HISTORIC LANDMARK COMMISSION STAFF REPORT

Planning and Zoning Division
Department of Community and
Economic Development

**Conboy Residence,
Addition & PLNHLC2009-00706
1014 3rd Avenue
August 5, 2009**

NEW SITE PLAN

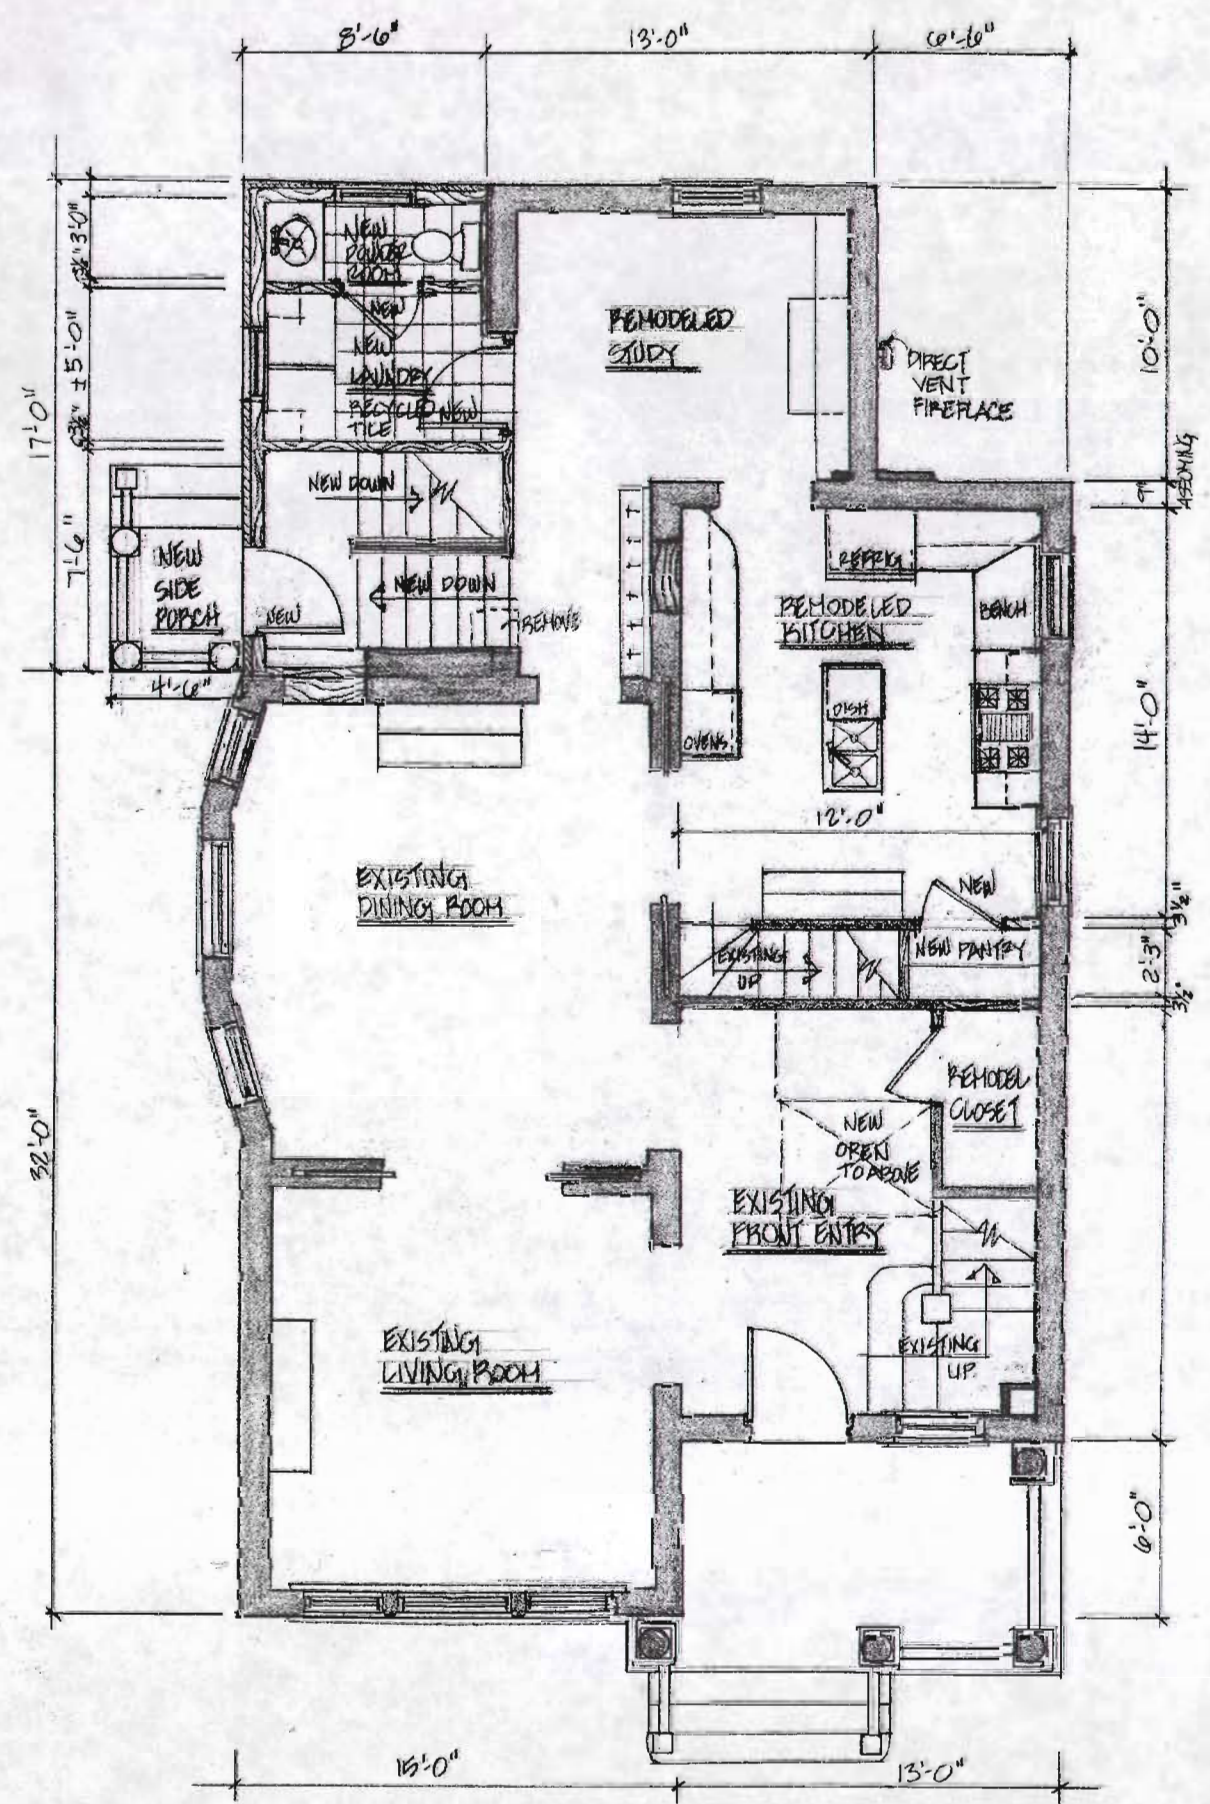
Discussion for Standard 9: The proposed rear addition is no taller than the existing house, is inset from the original footprint, and utilizes modern materials all of which help to differentiate the old from the new. A portion of the addition is wider than the existing house; however this takes place towards the rear of the building and will not be a significant change to the building, as seen from the street. The addition’s 123-square feet is subordinate to the 1,213-square feet of the existing building. The addition could be removed without destroying any significant character defining features.

Finding for Standard 9: The sizes, scale, design and location of the addition is appropriate for the existing building and does not destroy nor cover character defining features. The addition meets this standard.

NEW GARAGE PLAN & ELEVATIONS

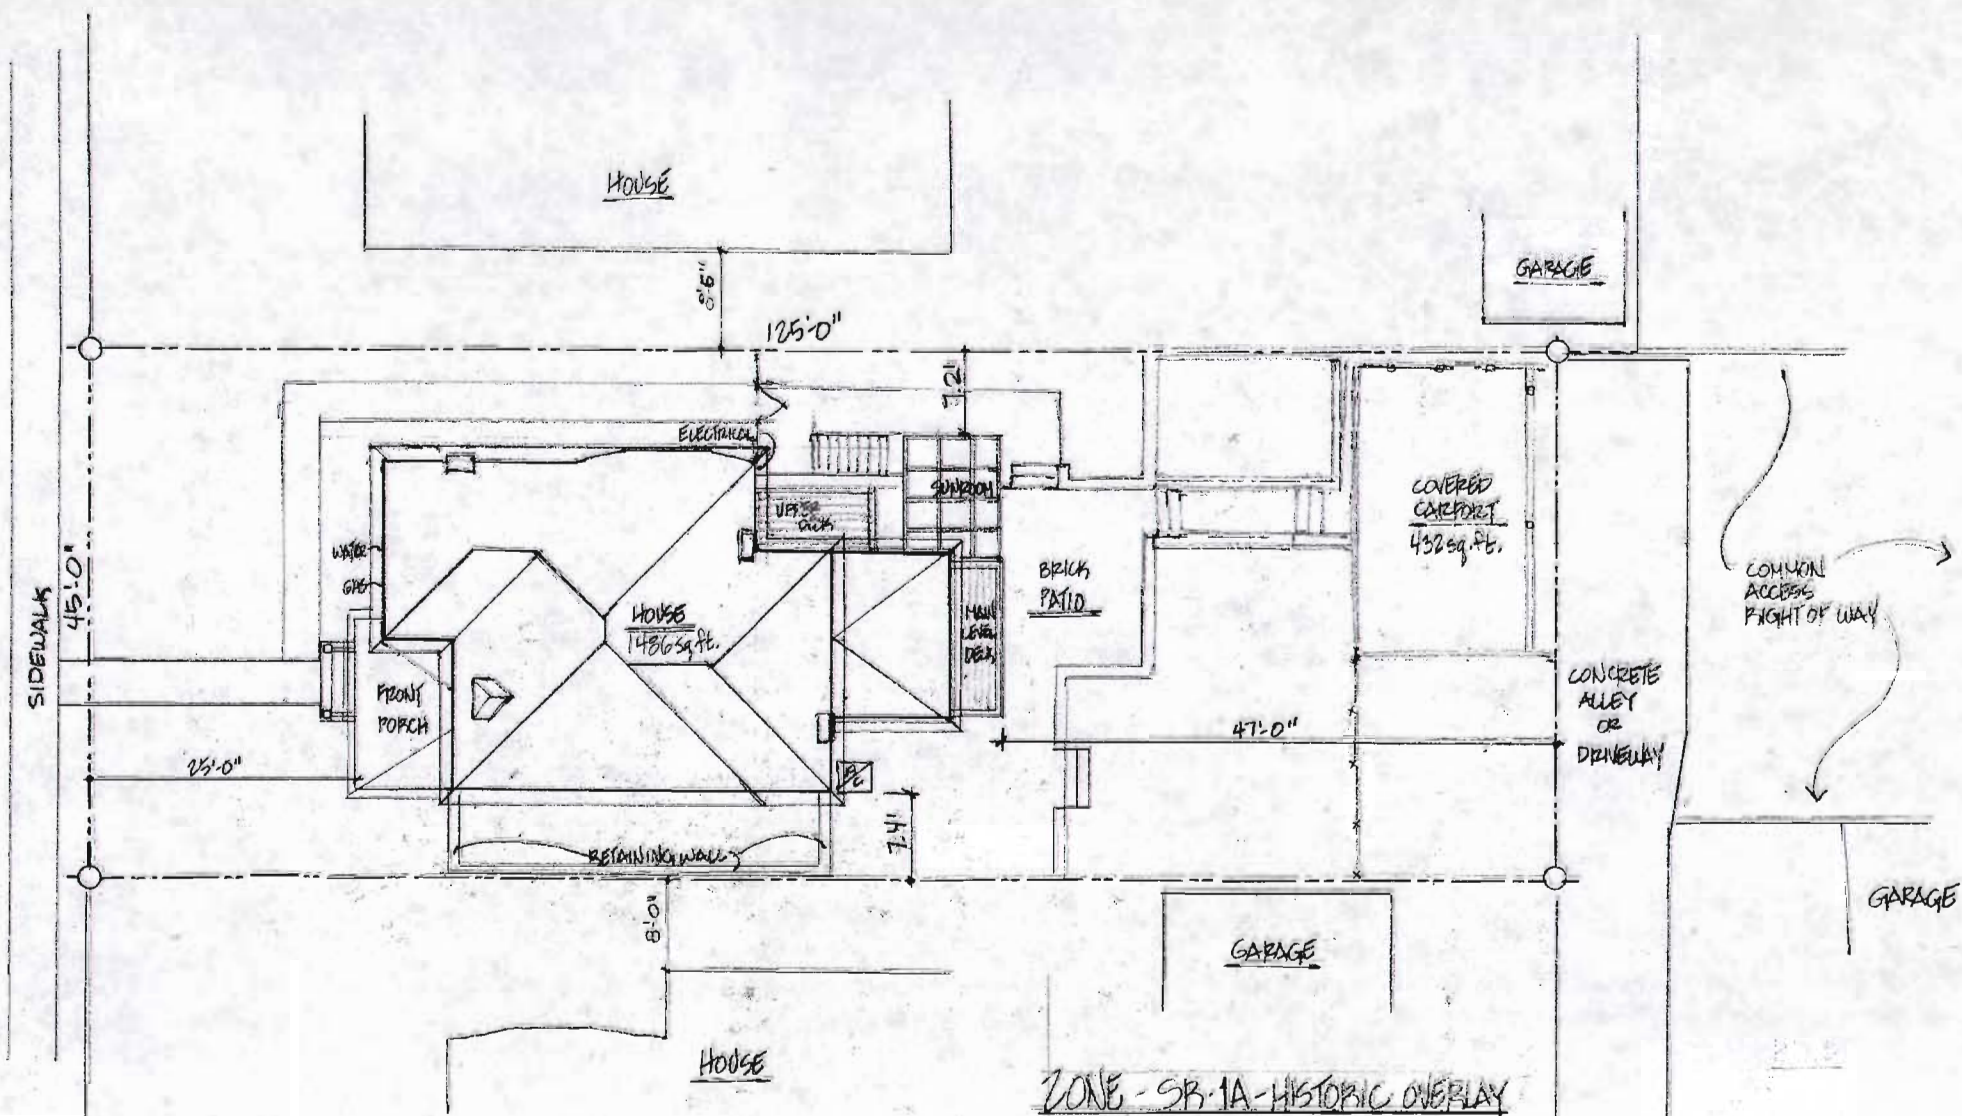
The garage is located to the rear of the property, has a roofline similar to the main structure, does not employ aluminum or vinyl, and has two auto doors rather than a double door.

Finding for Standard 3 and 8: This project does not create a false sense of history and the design location and materials of the proposed garage are appropriate for the site. The project meets these standards.
